**RE: Noah's Event Center
Vista Fuentes Rd NW
Grading and Drainage Plan
Engineers Stamp Date 4/14/15 (C12D003B4)**

TITLE: **VISTA FUENTE ROAD IMPROVEMENTS**

BERNALILLO COUNTY PUBLIC WORKS DIVISION ENGINEERING GROUP			
TITLE: VISTA FUENTE ROAD IMPROVEMENTS UTILITY IMPROVEMENTS VISTA FUENTE RD			
DESIGN REVIEW COMMITTEE	CITY ENGINEER APPROVAL	MO./DAY/YR.	MO./DAY/YR.
CITY PROJECT NO. 5844.86		ZONE MAP NO. C-12-Z	SHEET 5 OF 6

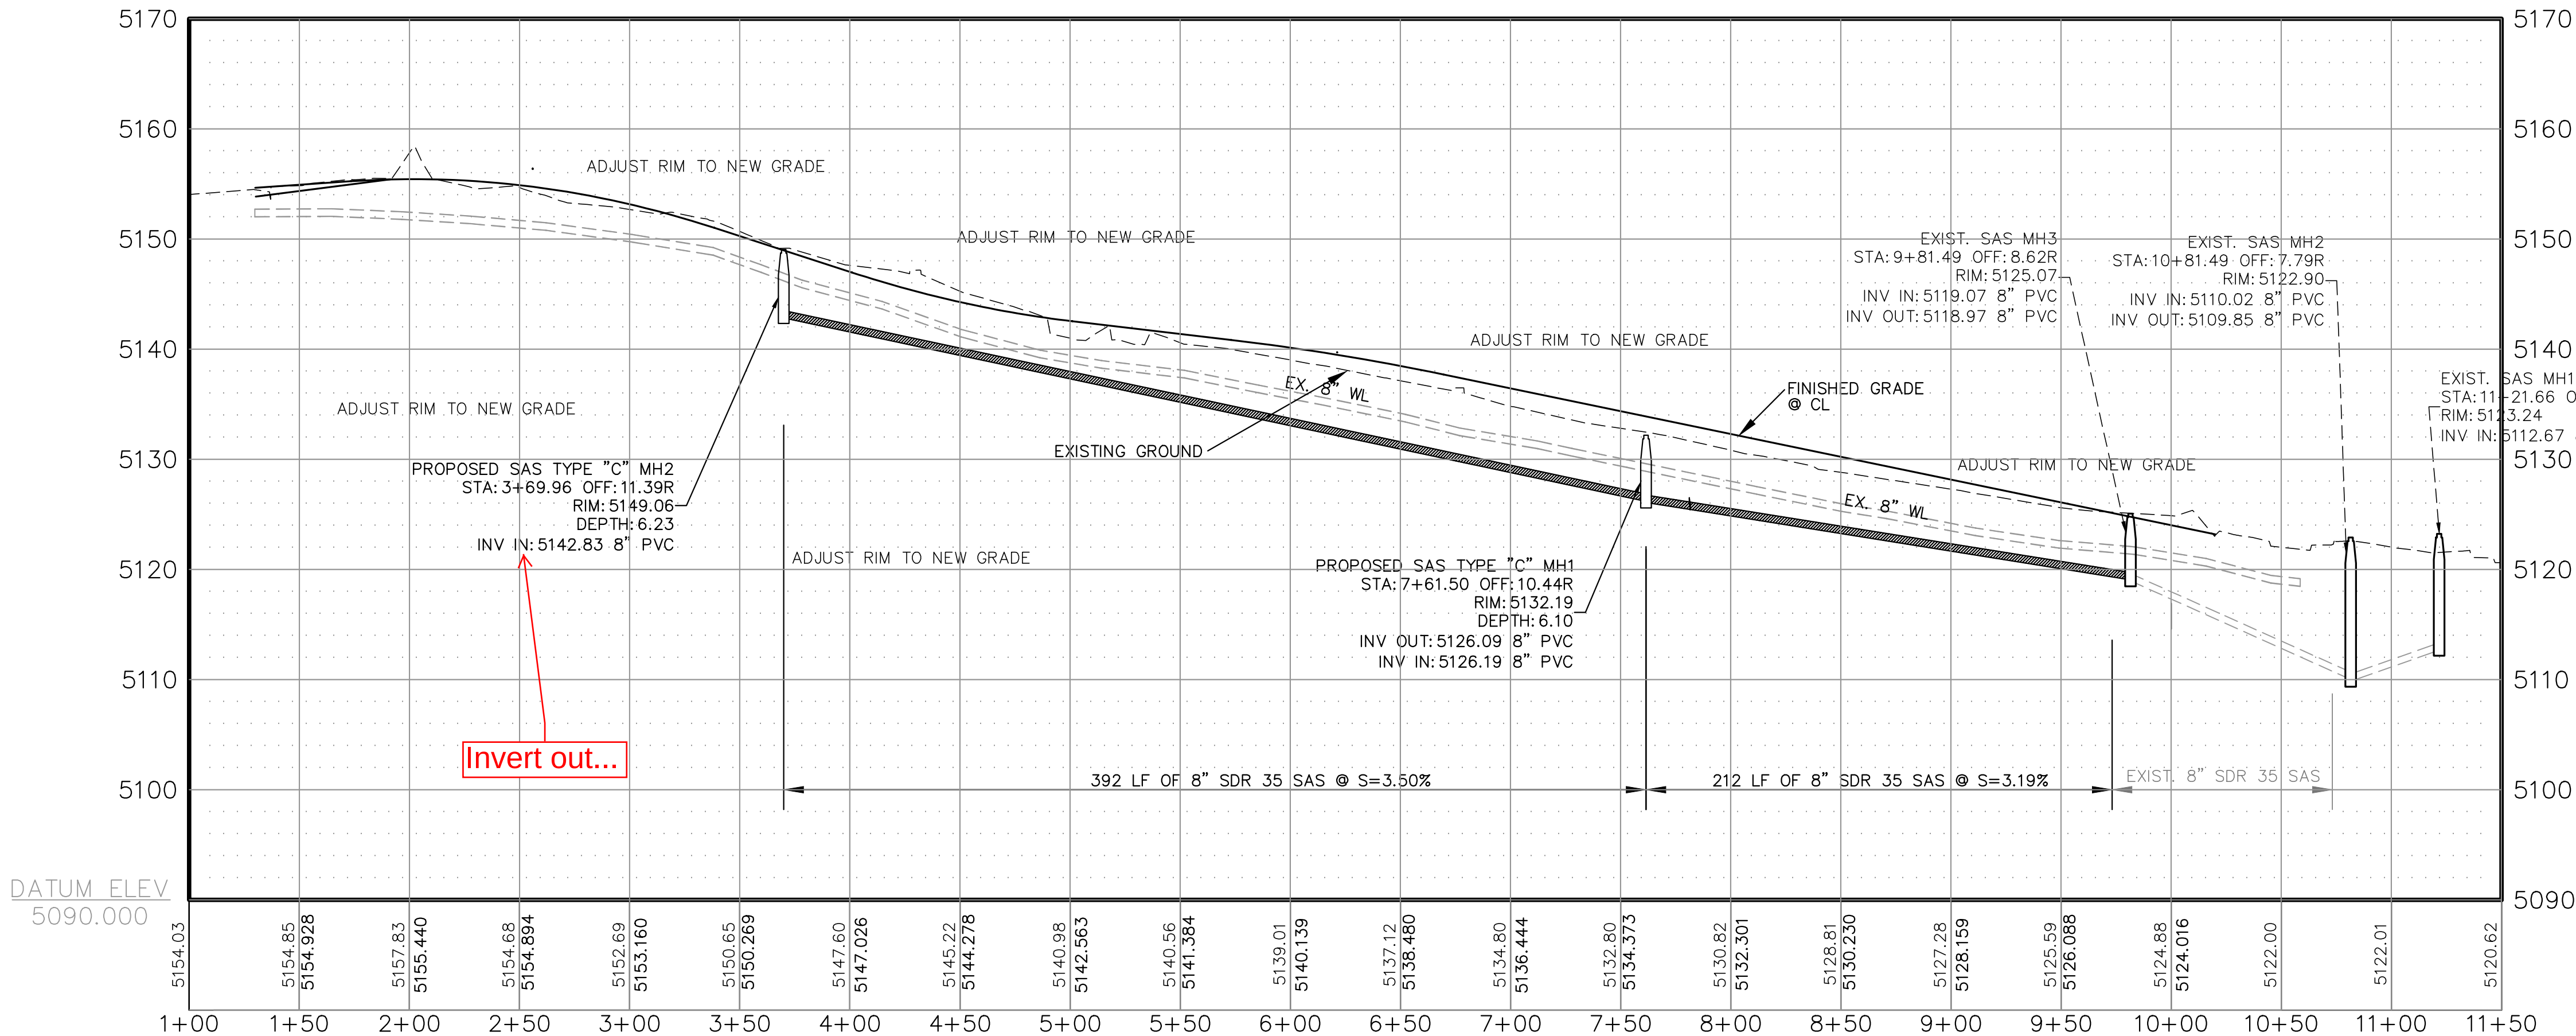
Invert out...

BERNALILLO COUNTY PUBLIC WORKS DIVISION ENGINEERING GROUP	
TITLE: VISTA FUENTE ROAD IMPROVEMENTS DETAILS	
DESIGN REVIEW COMMITTEE	CITY ENGINEER APPROVAL
LAST DESIGN UPDATE	
MO./DAY/YR.	
MO./DAY/YR.	
CITY PROJECT NO. 5844.86	
ZONE MAP NO. C-12-Z	
SHEET 6 OF 6

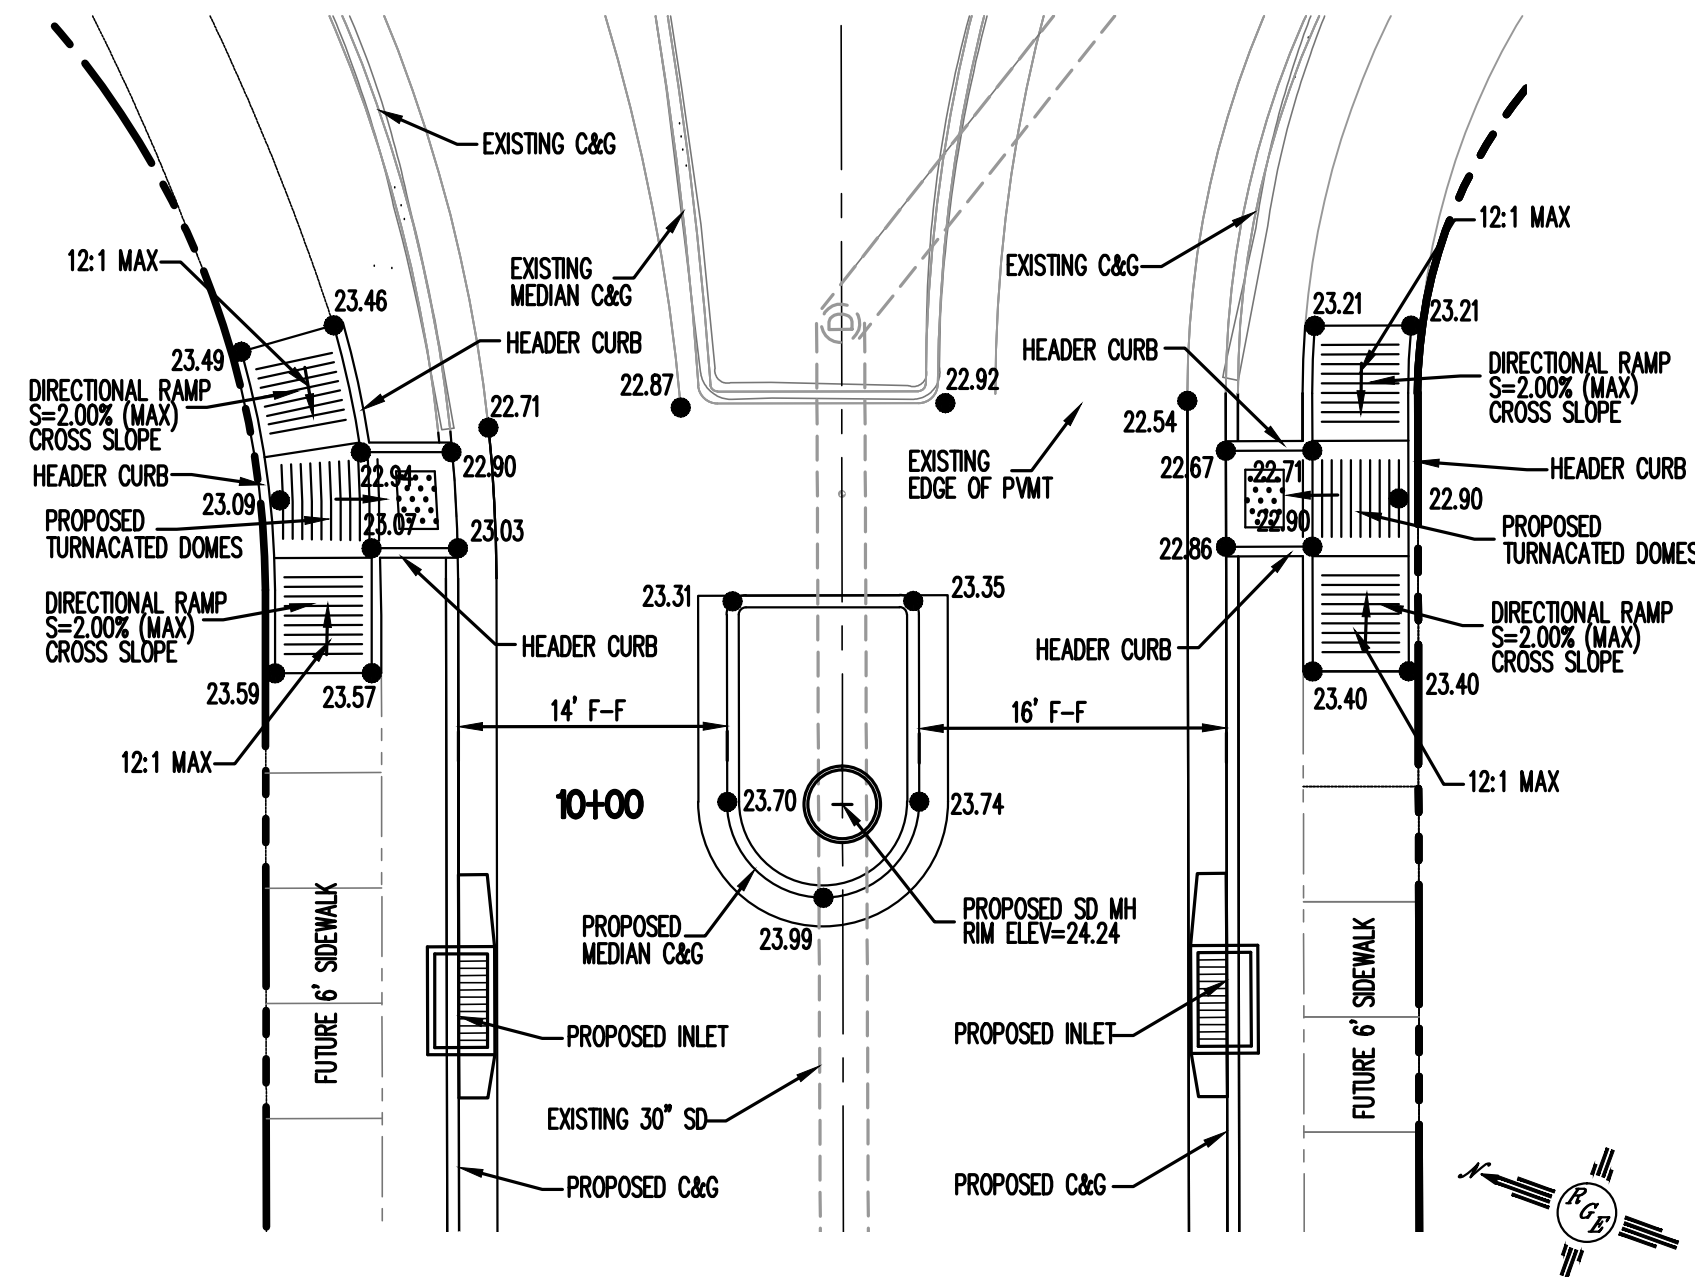
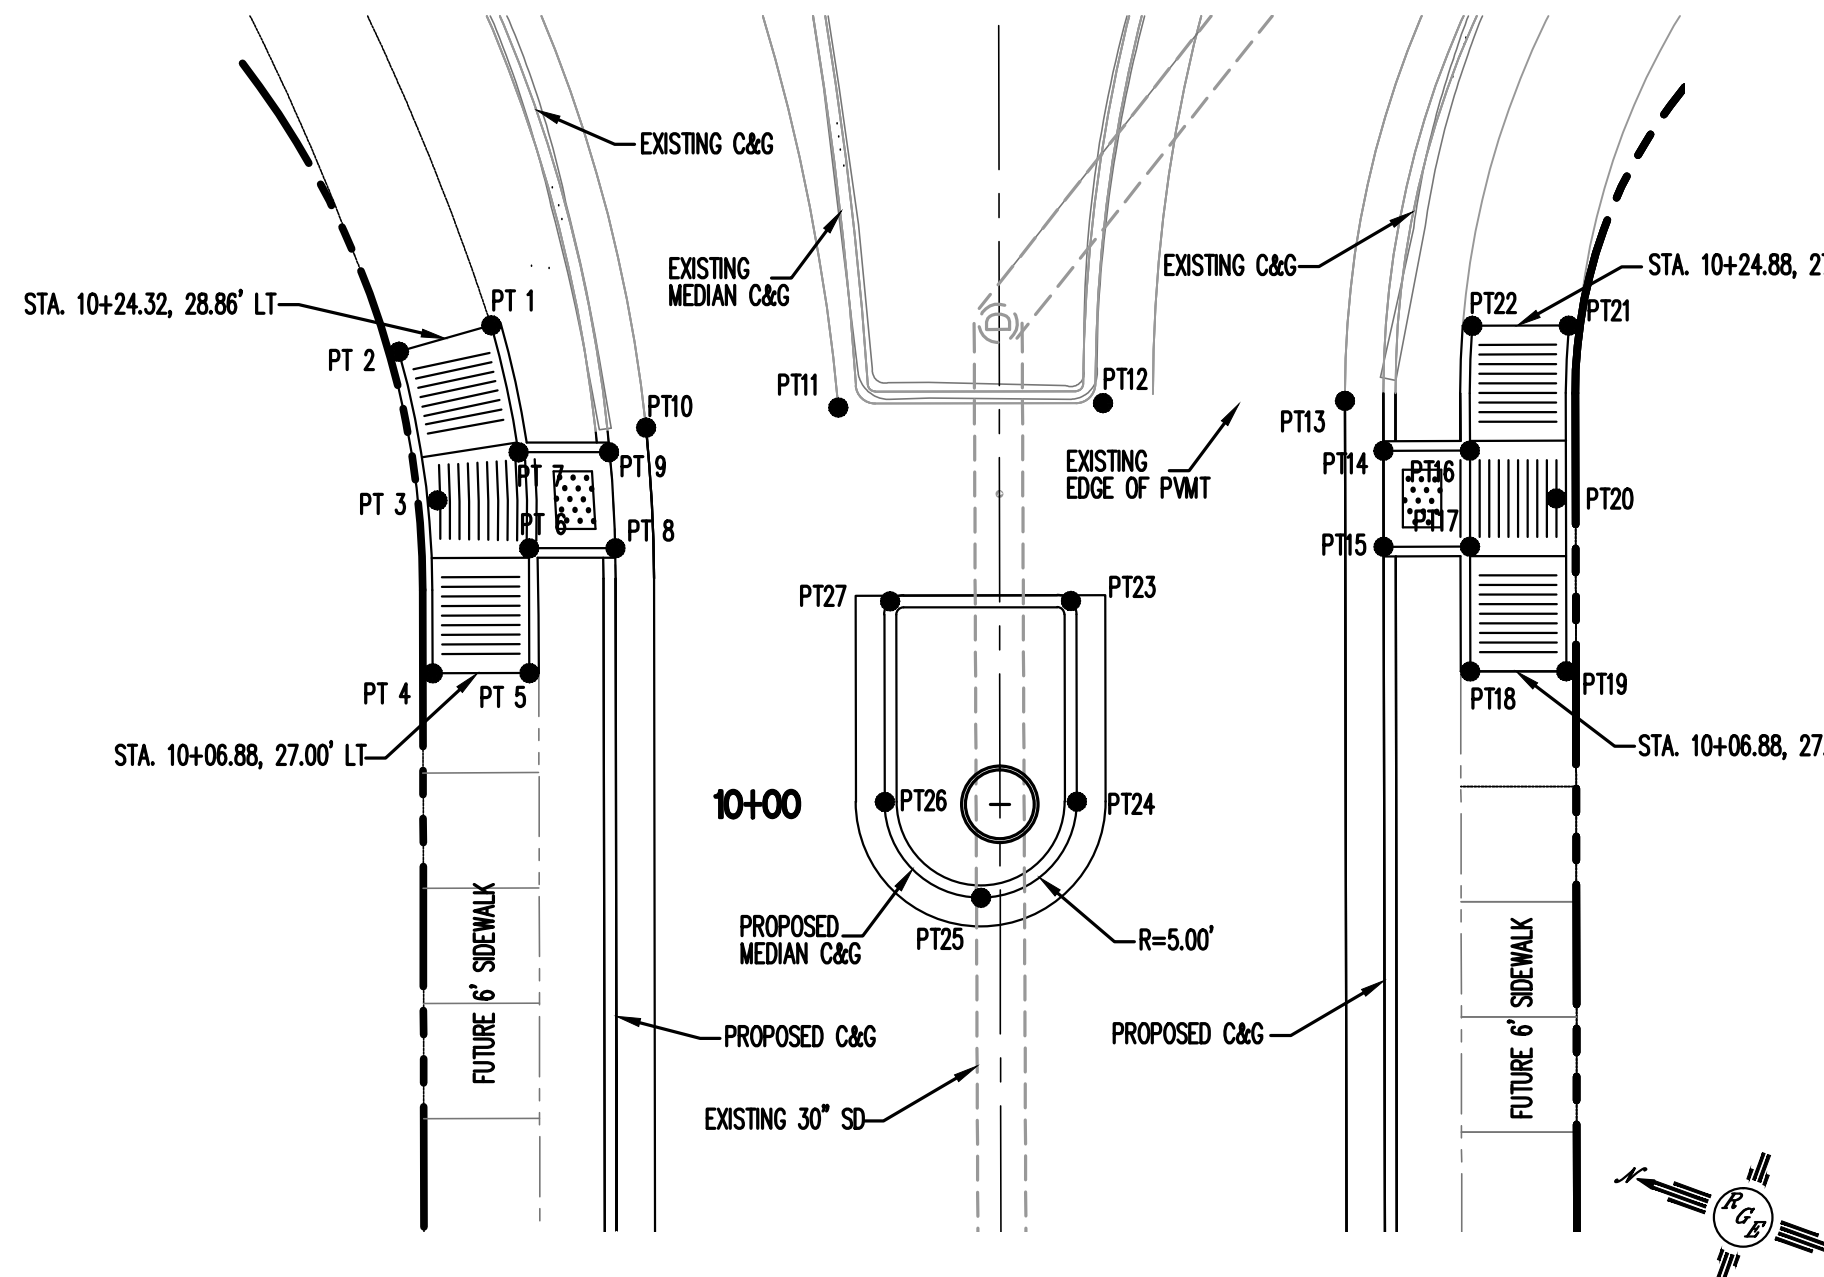
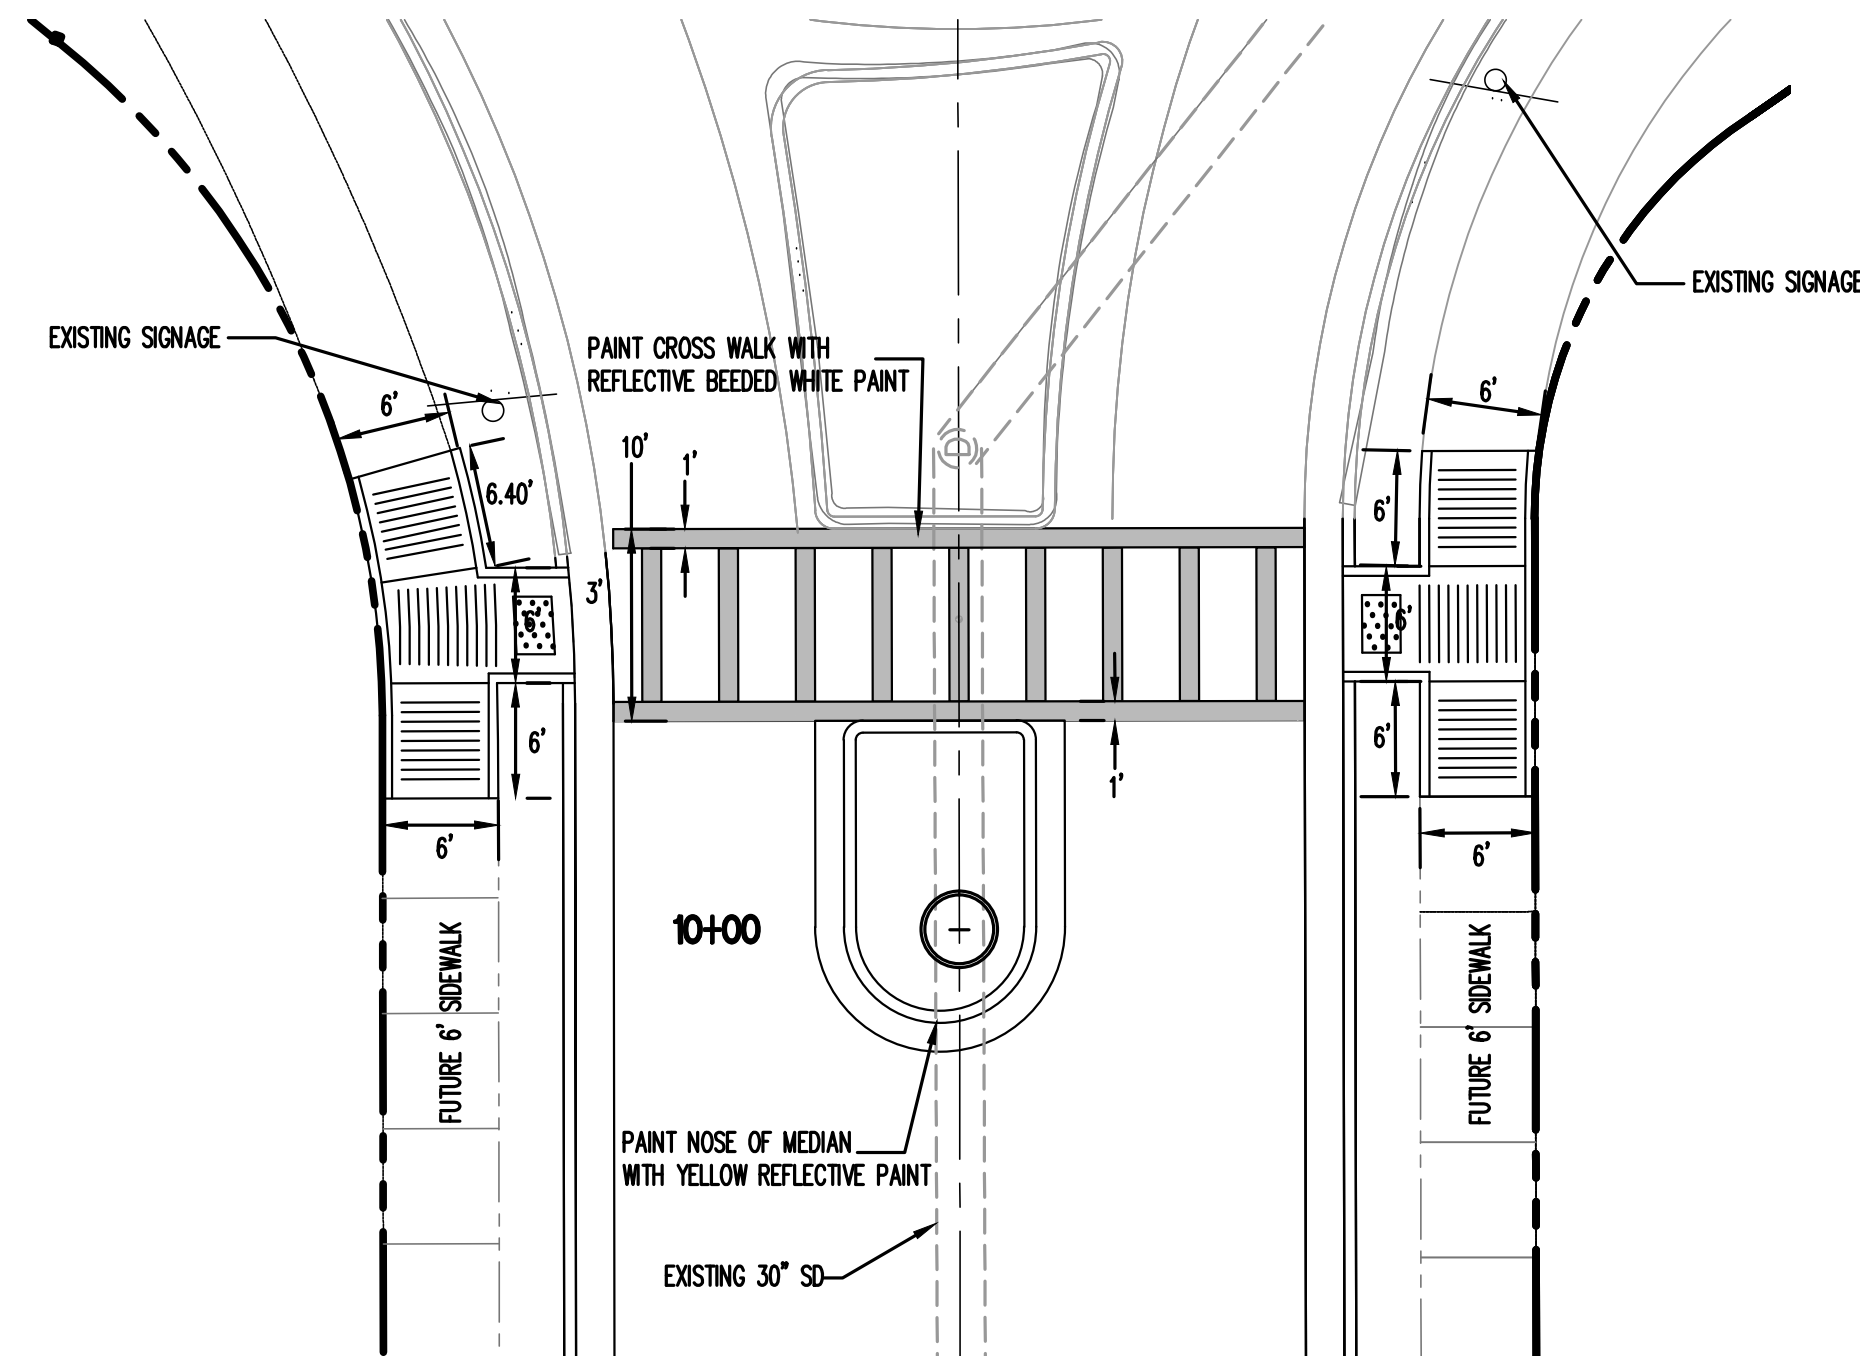
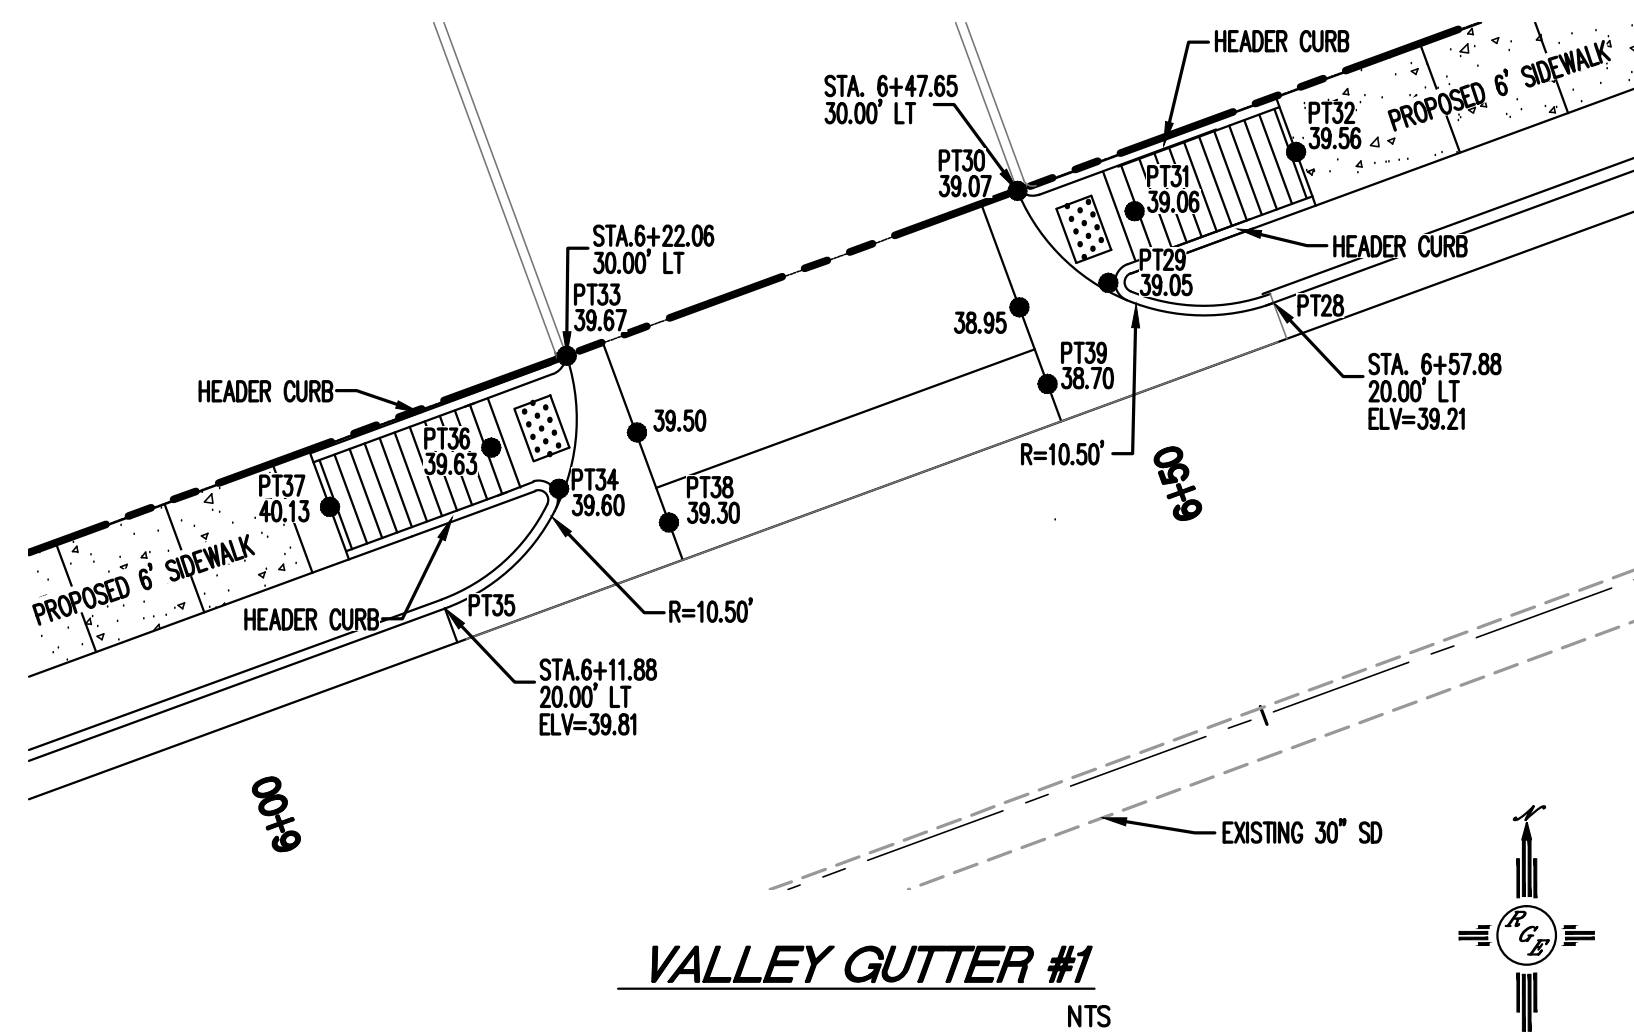
my misspelling....
should be "details".

Dan, we will need to make room for the catch basin
details... the type "A" with two grates.
